### **AMENDMENTS TO THE DRAWINGS**

### **REMARKS**

This is intended as a full and complete response to the Office Action dated January 9, 2008, having a shortened statutory period for response set to expire on April 9, 2008. Please reconsider the claims pending in the application for reasons discussed below.

FIG.3

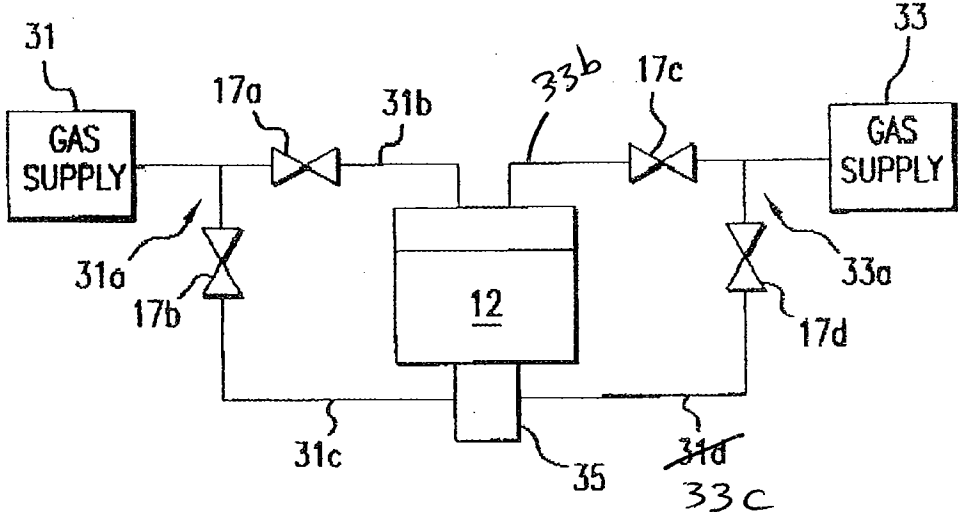
Figure 3 has been amended to include labels for feed lines 33b and 33c as required by the Examiner. No new matter has been added.

In the Drawings, Figure 3 has been amended to include labels for feed lines 33b and 33c. No new matter has been added.
